August 13, 2025

**RE: McDonallds
301 Eubank Blvd SE
Grading and Drainage Plan
Engineer's Stamp Date: 8/13/2025
Hydrology File: L20D004A
Case # HYDR-2025-00287**

C7.0 GRADING PLAN

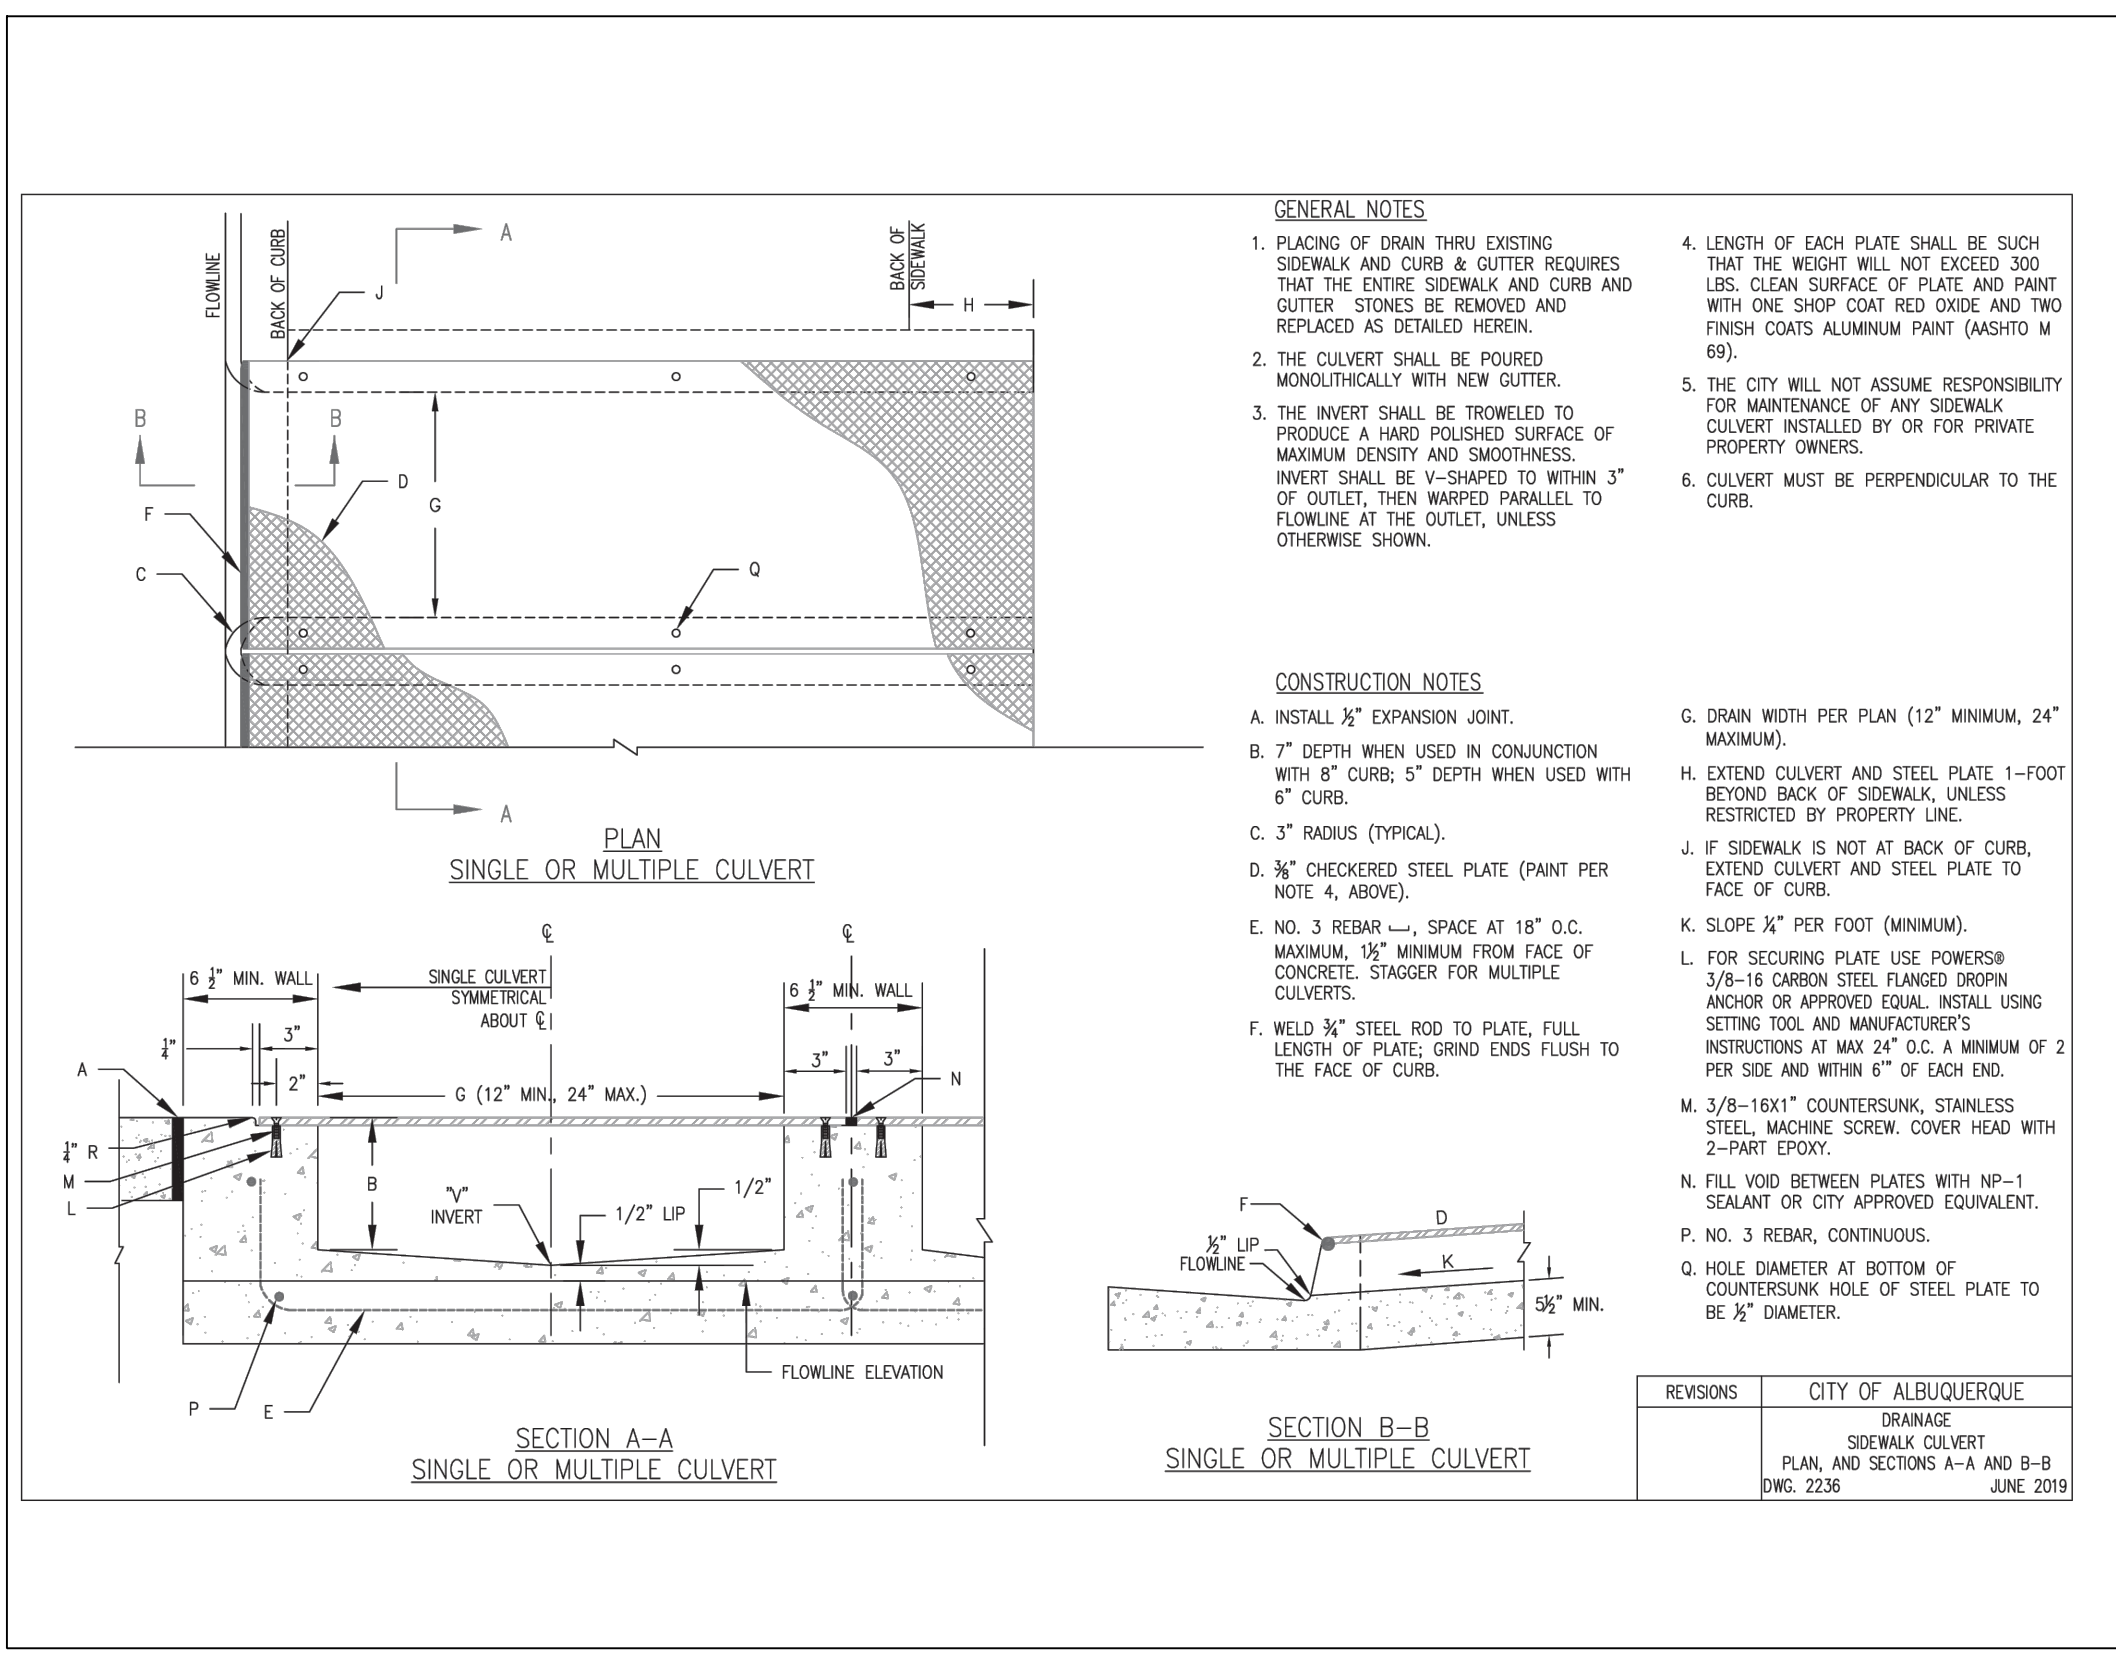
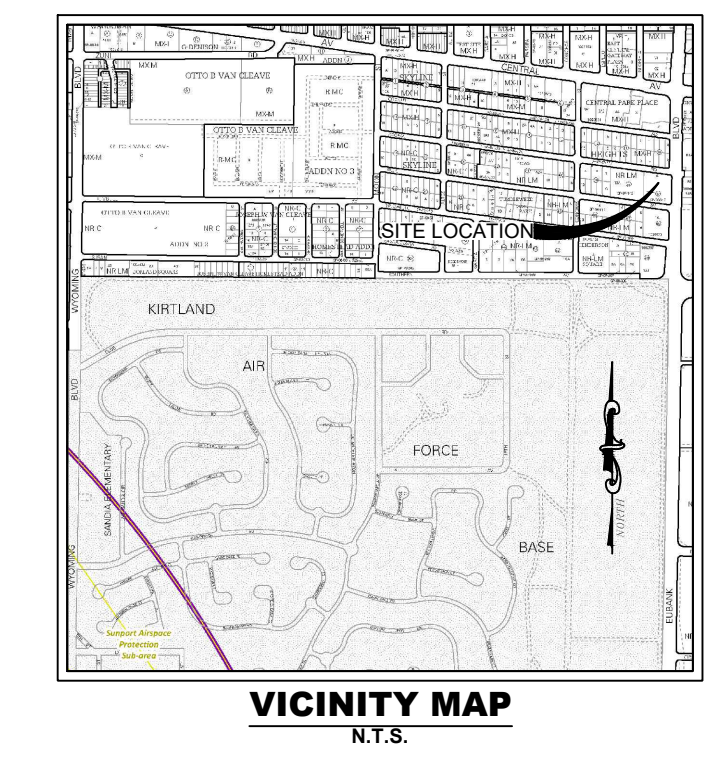
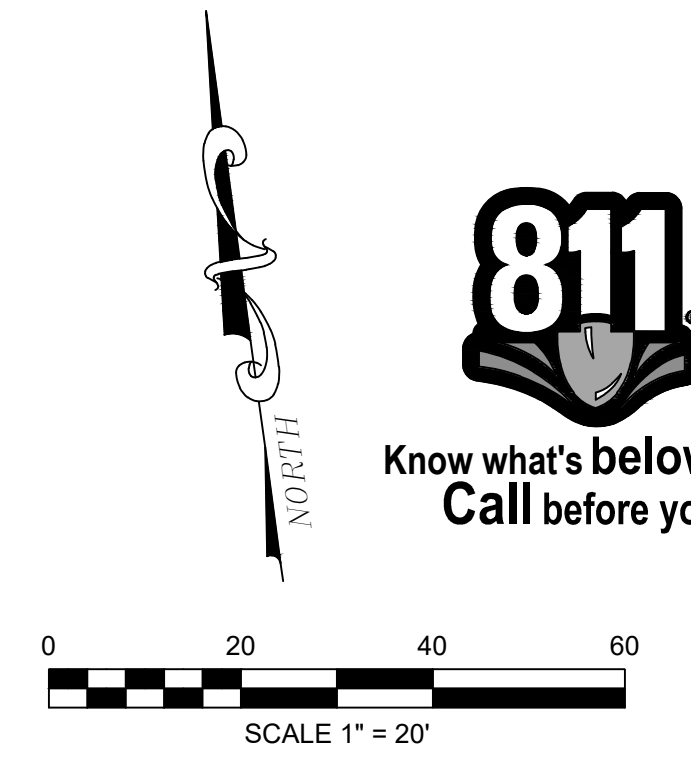
Based upon the information provided in your submittal received 08/13/2025, the Grading & Drainage Plan is approved for Building Permit, Grading Permit, and SO19 Permit. Please attach a copy of this approved plan in the construction sets for Building Permit processing along with a copy of this letter. Please note that a Pad Certification is not required for this site.

1. Engineer's Certification, per the DPM Part 6-14 (F): *Engineer's Certification Checklist For Non-Subdivision* is required.
2. Please provide the executed paper Drainage Covenant (latest revision) printed on one-side only with Exhibit A and a check for **\$25.00** made out to "Bernalillo County" for the detention pond per Article 6-15(C) of the DPM to Hydrology for review at Plaza de Sol.
